Video Intercom Second Generation
Villa Door Station V2.1.3 Build191015
Release Note (2019-12-11)

Device Model: DS-KV8413-WME1 DS-KV8213-WME1 DS-KV8113-WME1 DS-KV6113-WPE1 DS-KV6113-PE1 DS-KV6103-PE1	Firmware Version	V2.1.3_build191015
	iVMS4200 Version	3.1.0.5_build191011
	Hik-Connect APP	v3.10.3_345742
	Batch tools	1.0.1.8buid20190114

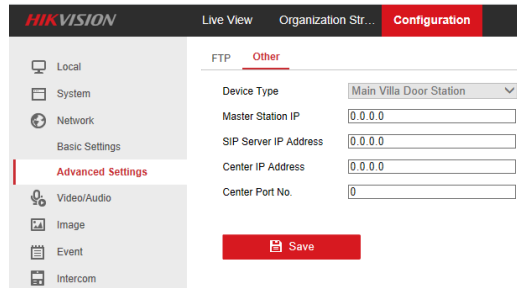
8) Support WEB to set the voice level
